Timbers of Black Forest Subdivision No. 1

Final Drainage Report

PCD File No: **SF2616**

All Terrain Engineering Project No: 25021

DP8 Swale - Min. Slope (Q100 = 22.1 cfs)

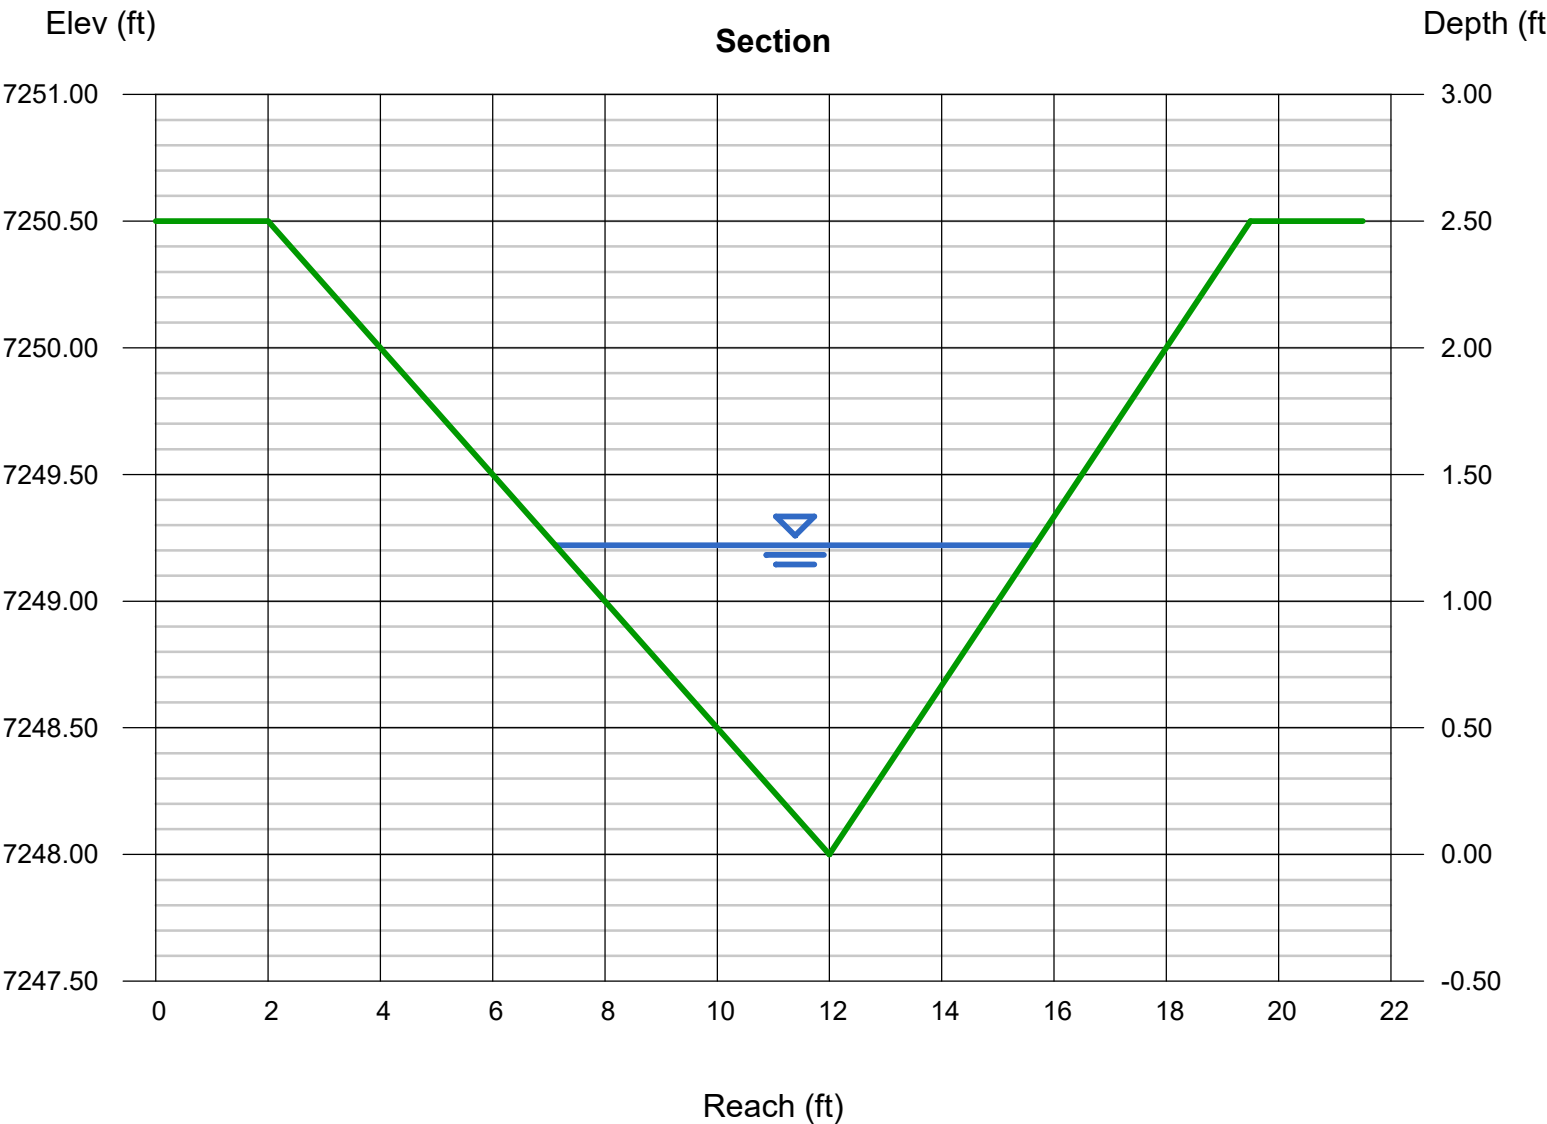
Please provide Froude number for all swale calculations.

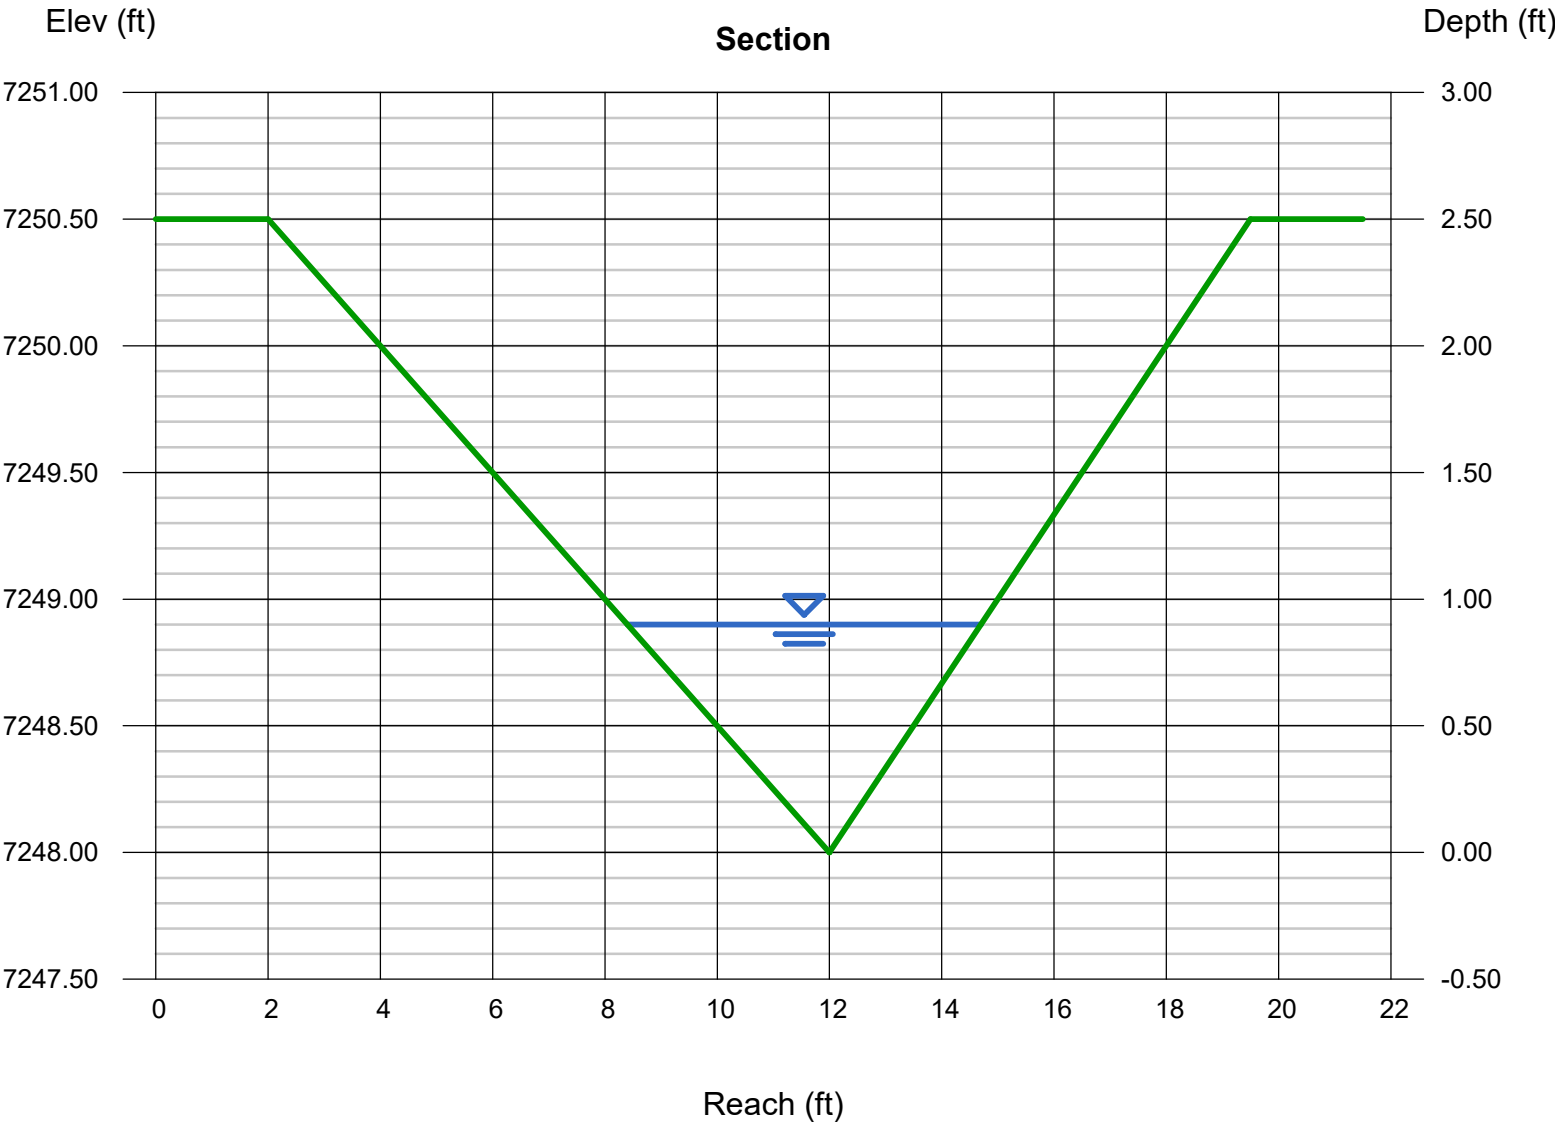
Swale does not meet velocity constraints in this section. Please provide additional protection

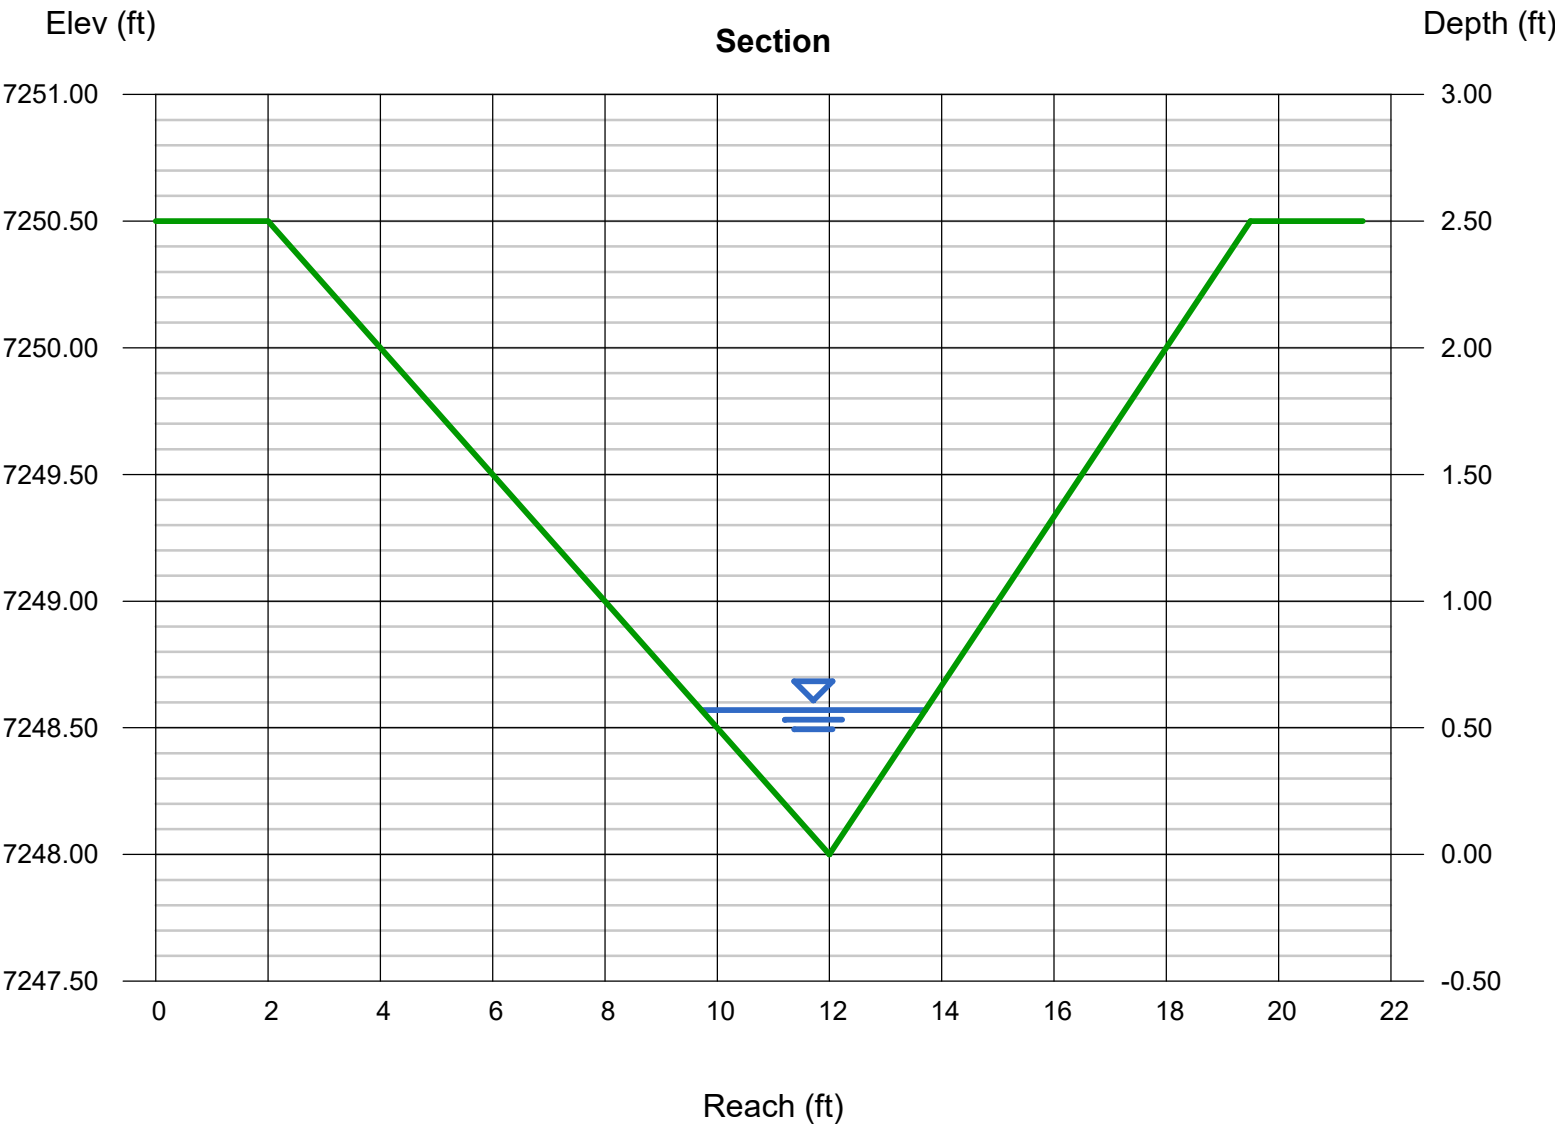
Swale does not meet velocity constraints in this section. Please provide additional protection

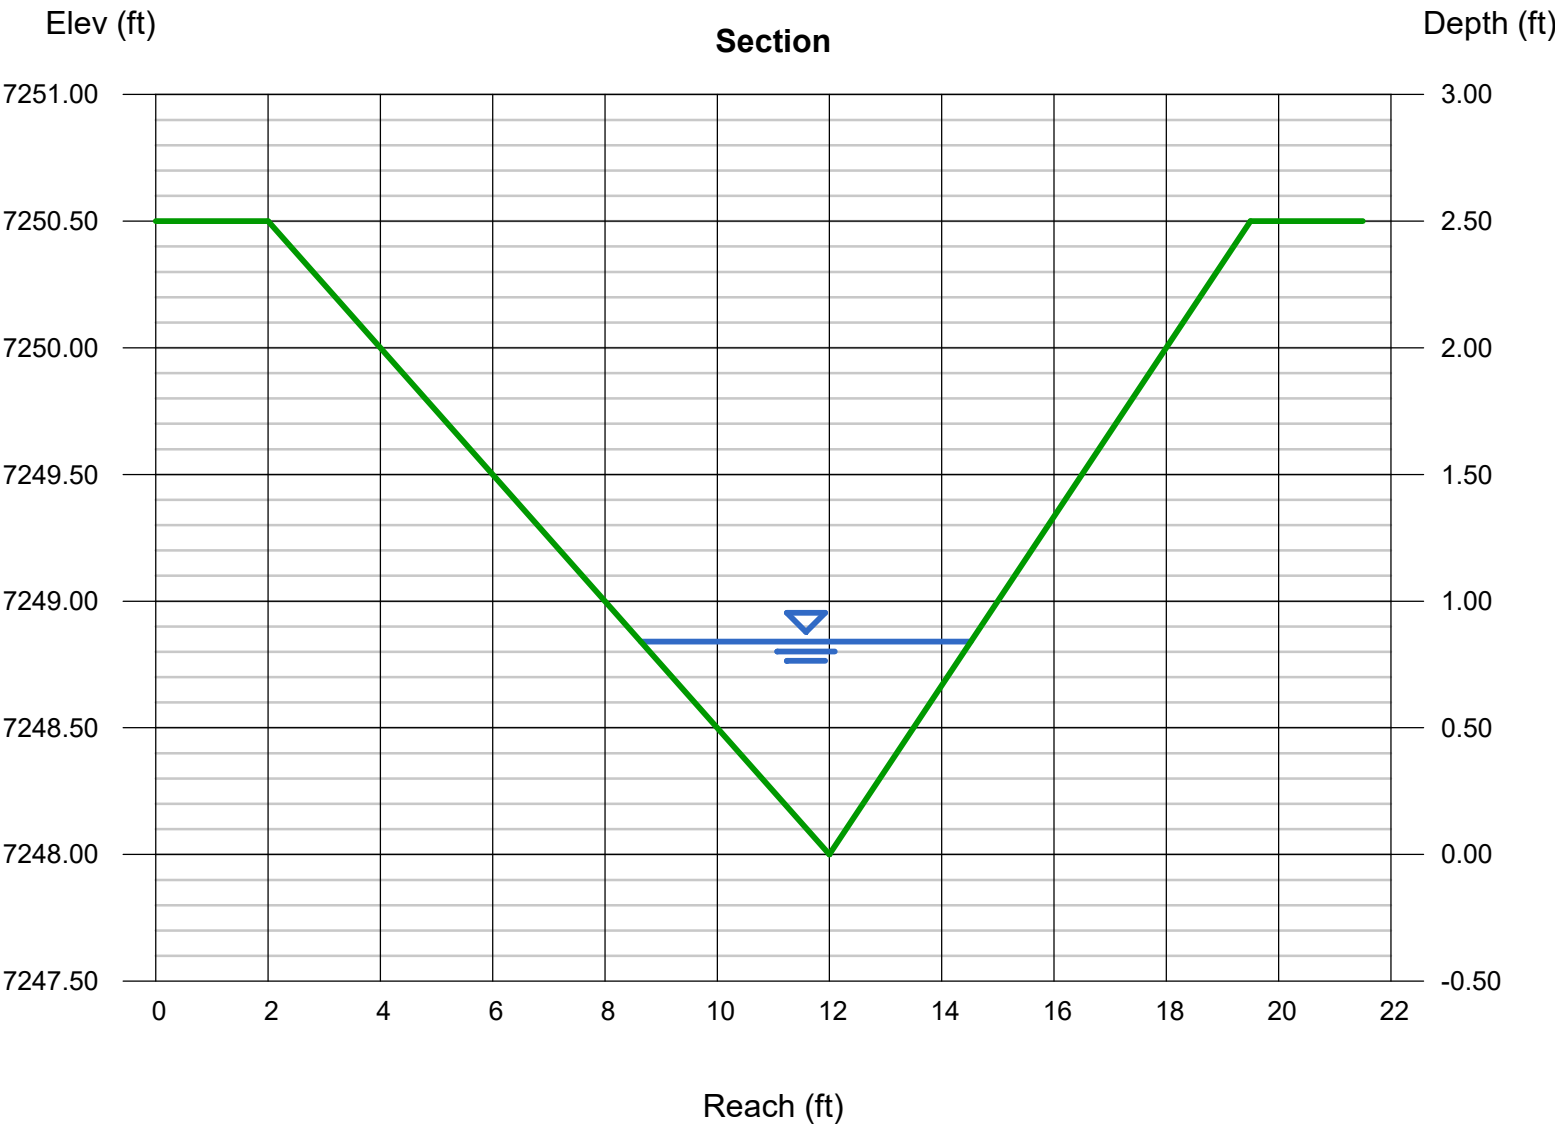
Swale does not meet velocity constraints in this section. Please provide additional protection

EXISTING DRAINAGE MAP

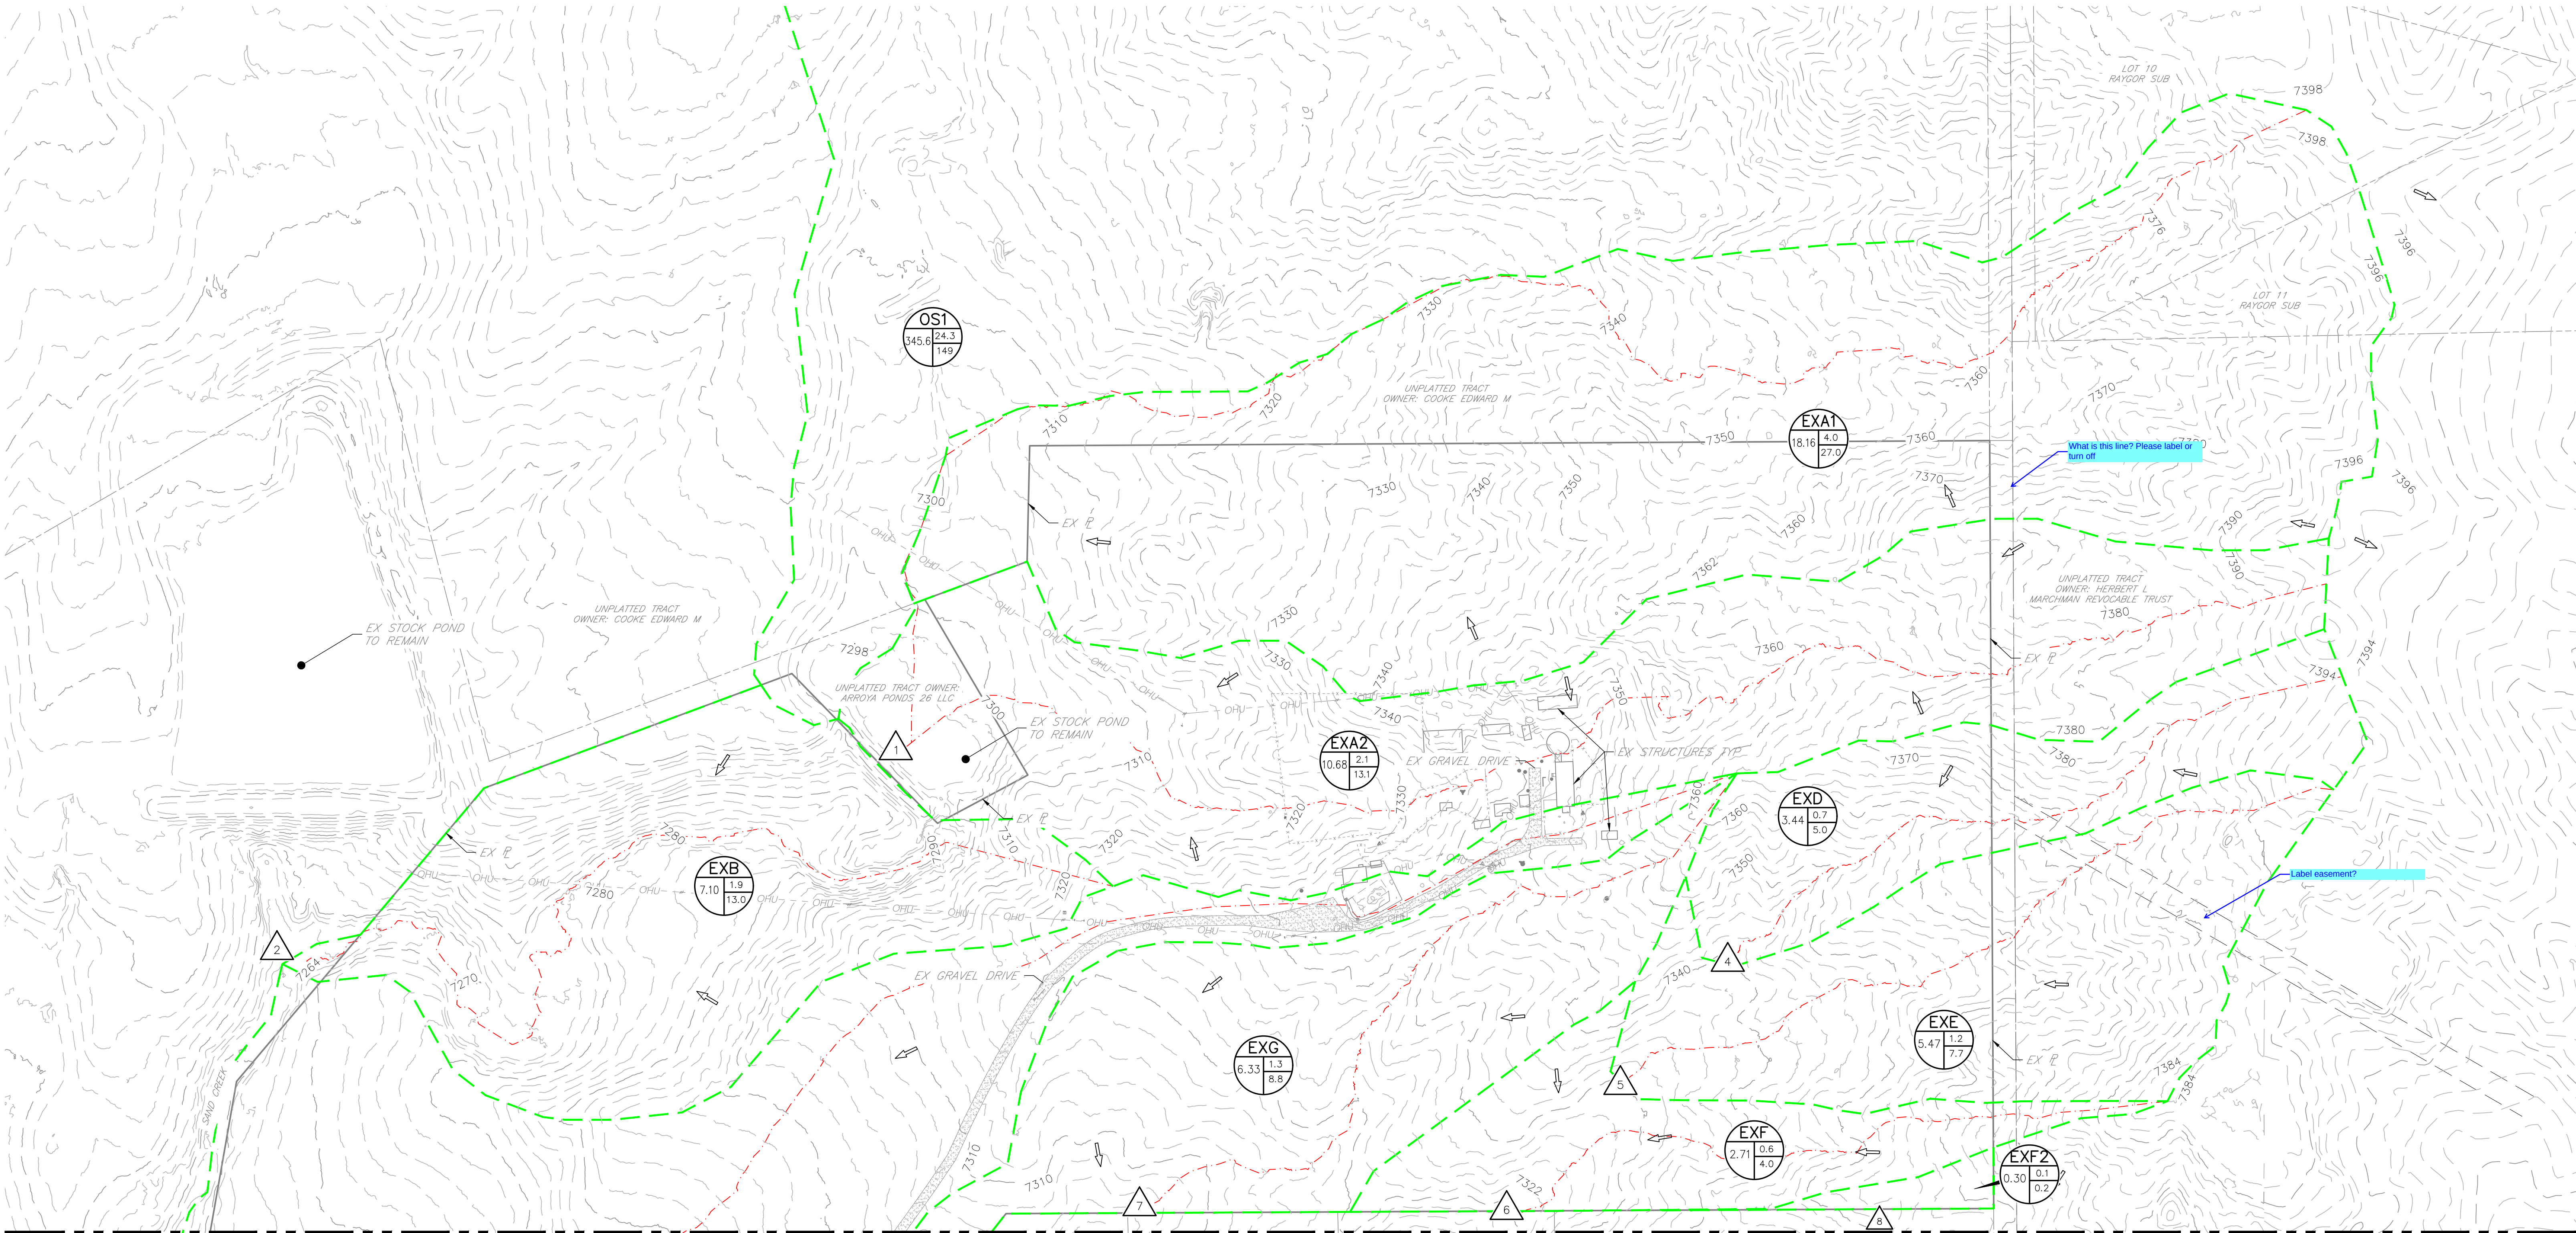
Please show/label flowline for all existing swales (all drainage maps).
